**PUBLIC INTEREST REVIEW FOR GROUND WATER APPLICATIONS**

SUBJECT: Application G- 17650 Supersedes review of \_\_\_\_\_  
Date of Review(s)

**A. GENERAL INFORMATION:** Applicant's Name: Kim McCreary County: Malheur

Application G-17650, Kim McCreary, Duck Ranch, LLC

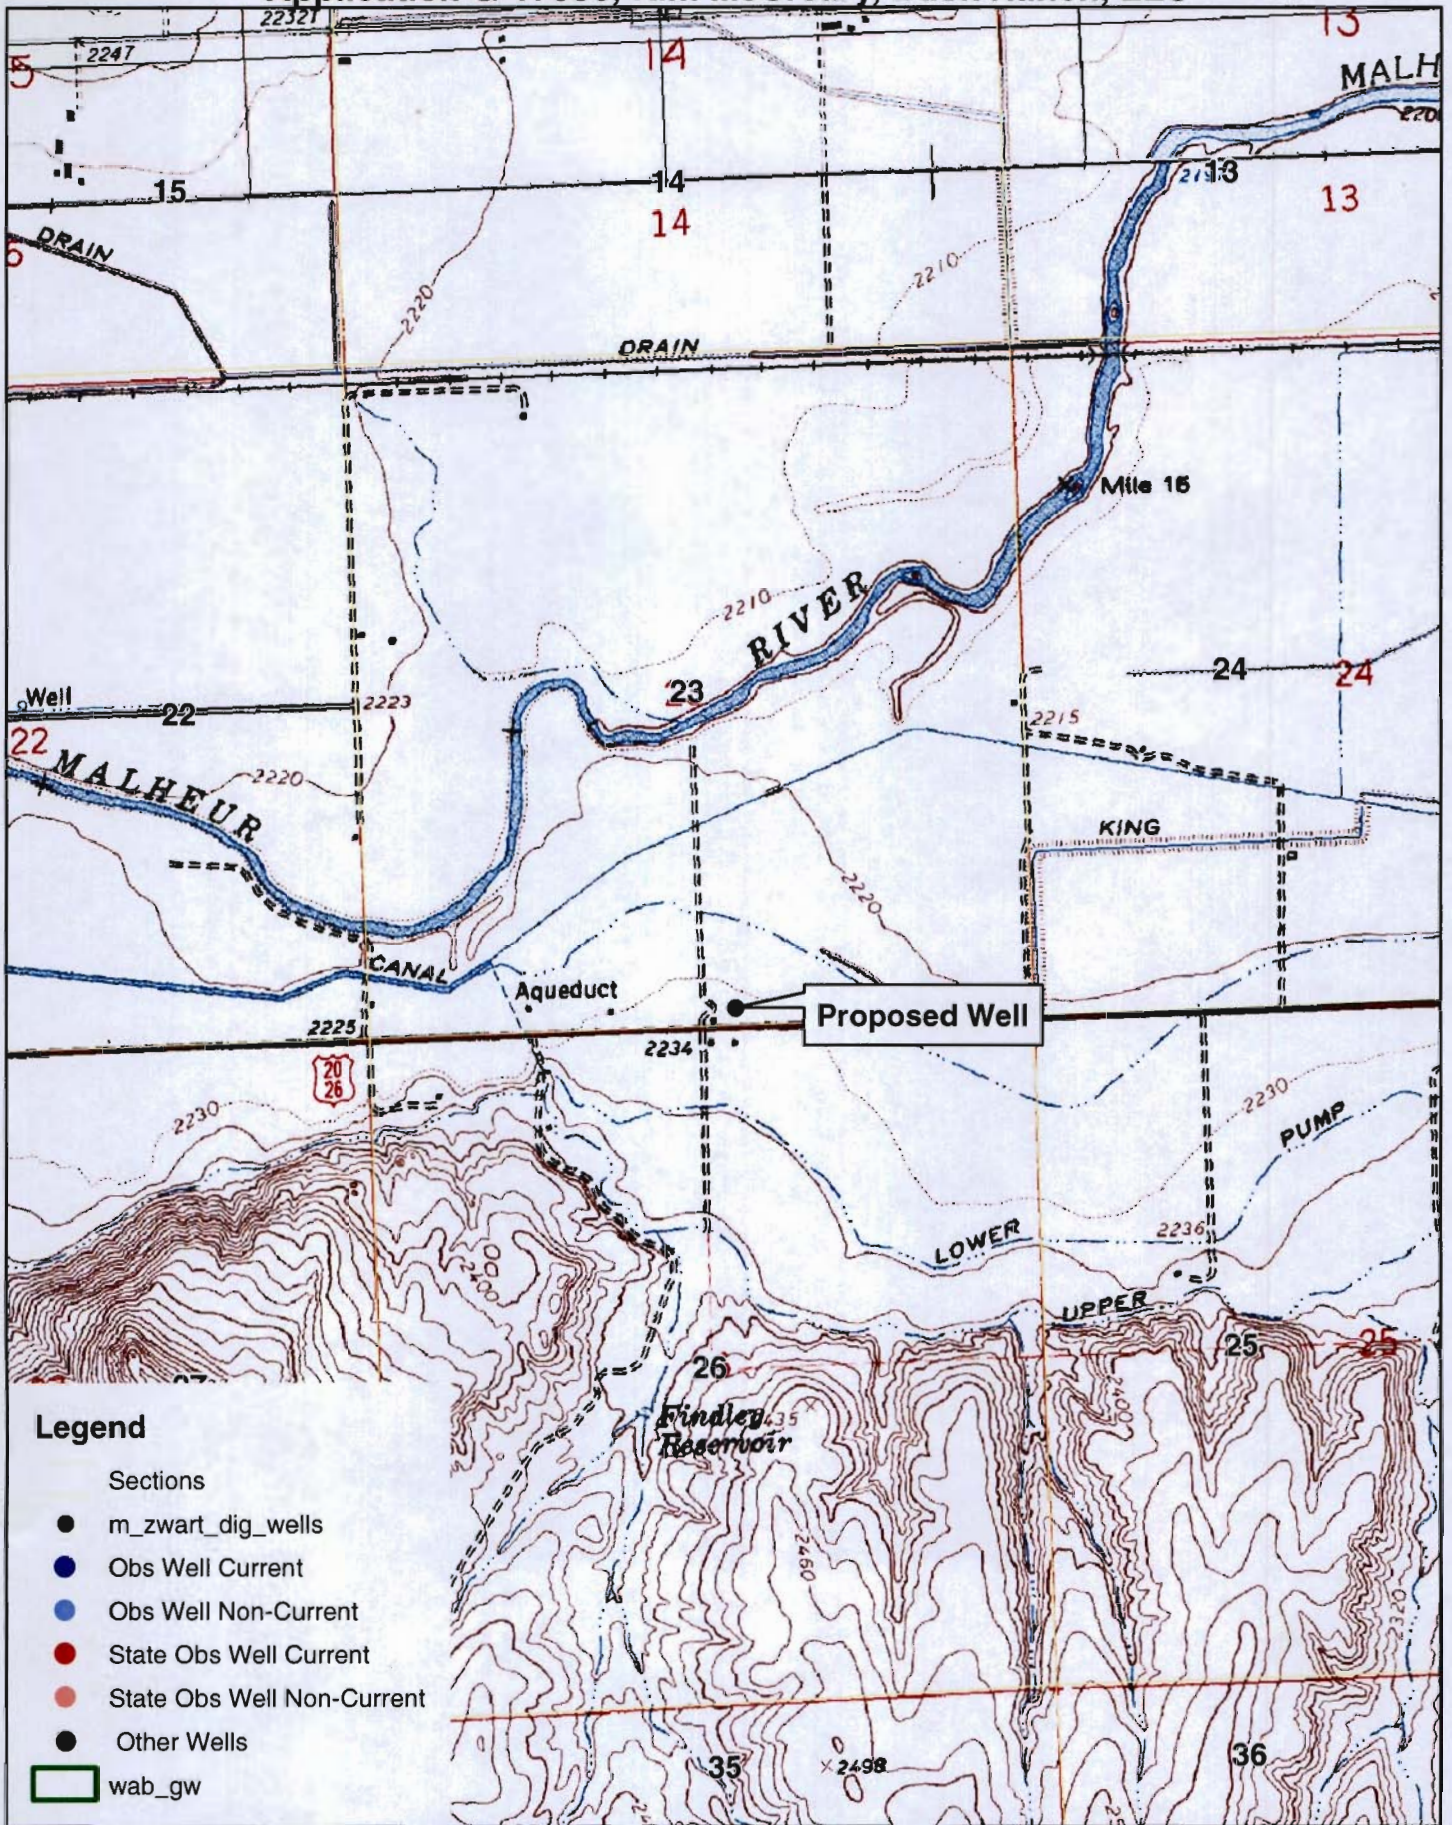
B3. **Ground water availability remarks:** There are no nearby wells penetrating exclusively the Glenns Ferry Formation with long-term water-level records. Most such wells also develop the overlying Quaternary sand and gravel aquifer, which is usually the higher yielding aquifer. Water levels are generally stable in the local observation wells.

**Condition 7K is recommended to ensure that the applicant constructs the well as is proposed in the application. The proposed seal depth is likely to be adequate to prevent development of the shallow sand and gravel aquifer in this area.**

- i.  The permit should contain condition #(s) 7C, 7K (40 feet, the Quaternary sand and gravel aquifer) ;
  - ii.  The permit should be conditioned as indicated in item 2 below.
